Product Support Bulletin 2016-002

SUBJECT: Tripp Rear Suspension Arm Mounting Reinforcement Kit

MACHINE MODEL(S): Tripp Models A-D

SERIAL NUMBER(S): S/N 760125 through 760569 (Machines built prior to March 2014)

Figure 1. Rear Arm Inspection Area

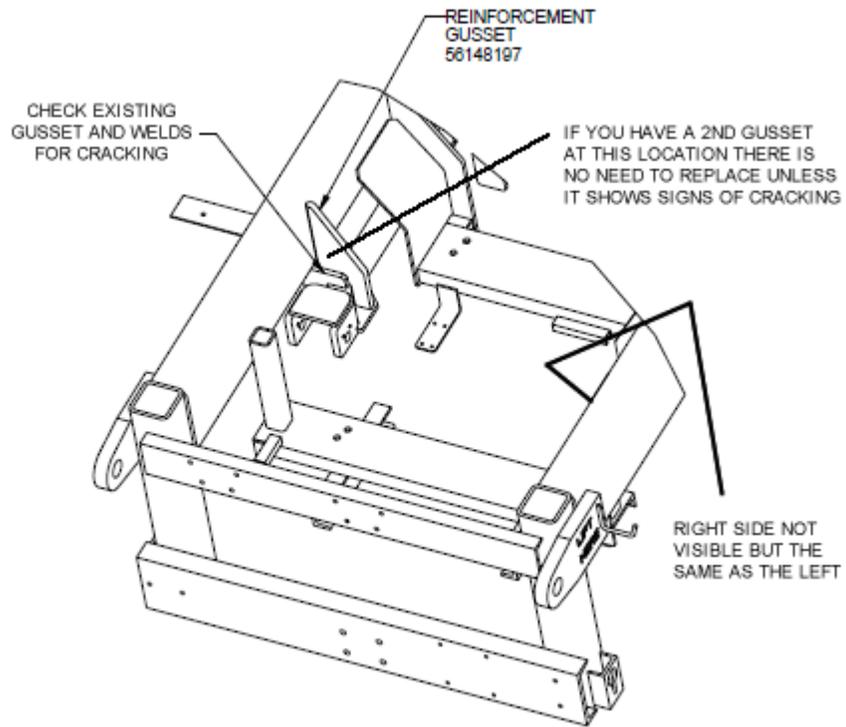
SUMMARY: Some customers with Tripp Machines in the S/N Range listed have reported main frame cracking near the rear suspension arm mounts.

OPERATIONAL IMPACT: If your machine has these cracks, the rear suspension arms could possibly break off during travel or operation of machine.

ACTION: Inspect both Rear Suspension Arm mountings for cracking at existing gusset and welds (See next page for picture showing the left rear mounting inspection area). Pay close attention to the welds at that location. If you spot cracks on the gusset or welds, contact Nordco Parts Department at 1-800-647-1724 to order your kit. Installation instructions are provided in the kit.

Nordco has developed a kit, Part Number 98760127, that reinforces that area of the frame. It is recommended that welding of this kit be done by an AWS Certified Welder.
